Title: Control cable clamps					
SB-C-002 Iss1	Related documents Modification: MC-329 CCAR No.: None	Compliance Category:			
Applicability		RECOMMENDED or			
Aircraft type & model:	Aircraft serial Nos. affected:	MANDATORY			
Cavalon pro	RSUK/CVLN/011				
The maintenance manual to be referenced is this stated or subsequent issue.		RSUK0335 Iss1

### Reason and overview of the Service Bulletin (cause of problem if known)

Fig 2 Control cable clamp

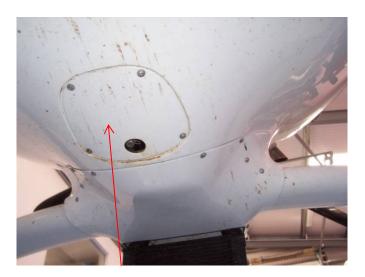
Under certain circumstances operating clearances in the push-pull control cables (for pitch and roll control) can allow the transmission of rotor vibration to the control stick. Fitment of these clamps enables the clearance to be adjusted and the vibration reduced (See Fig 2).

- 3. Apply Loctite 243 to the screw threads and fit one clamp to each control cable. Position so that the clamp is at the lowest point of the curve, clear of contact with the body (Fig 2).
